**01.Version**

DH-DC-A7FloorBoard--V1.0-PCB

**10.ADC**

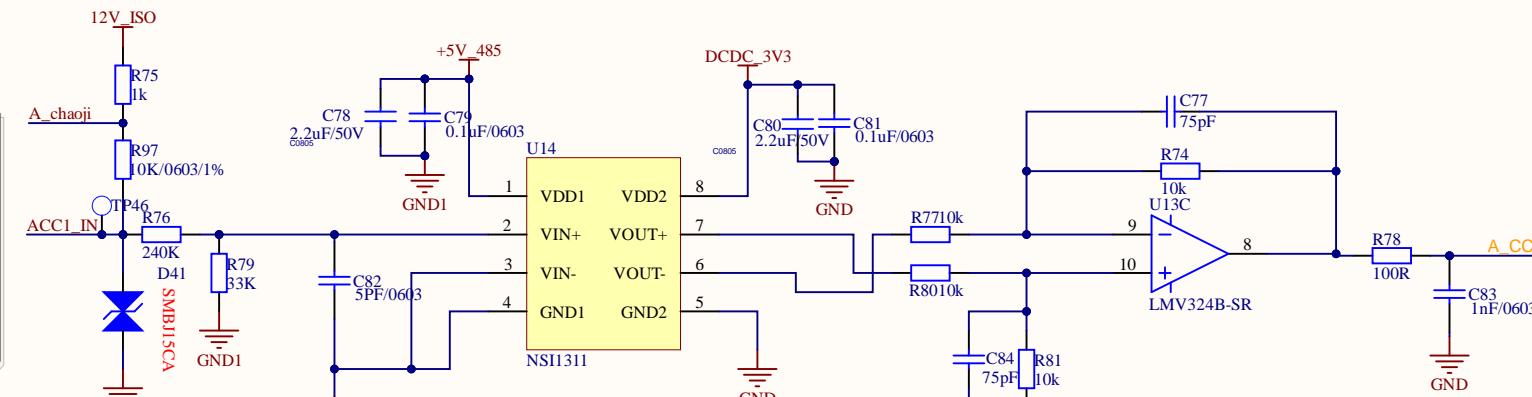
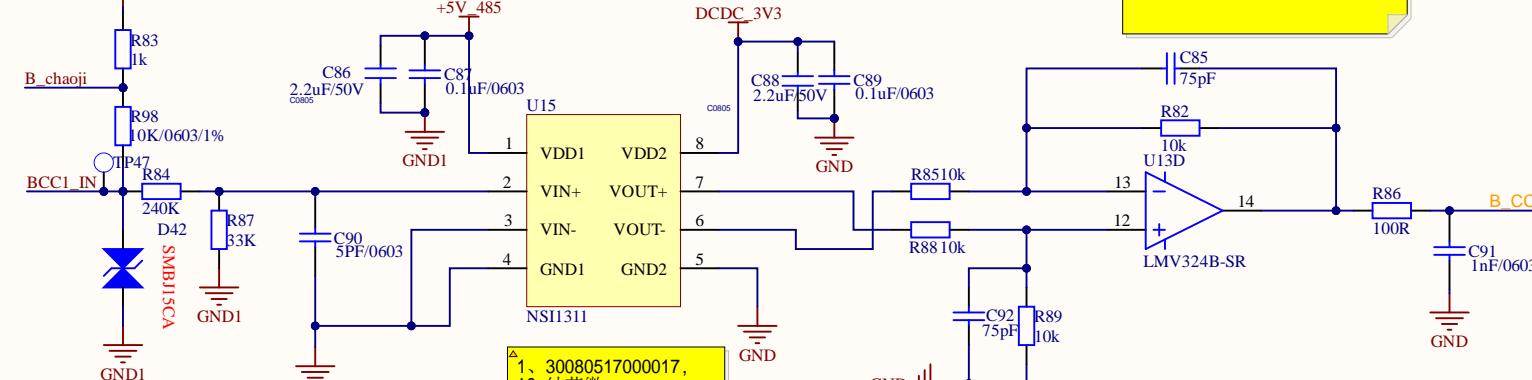
△关注点:  
1、CC1分压过大，降低采样精度，(应该是考虑隔离运放输入0.1-2V)  
2、隔离运放共地，失去隔离意义，且CC1电压不高隔离意义不大，关键是滤波。
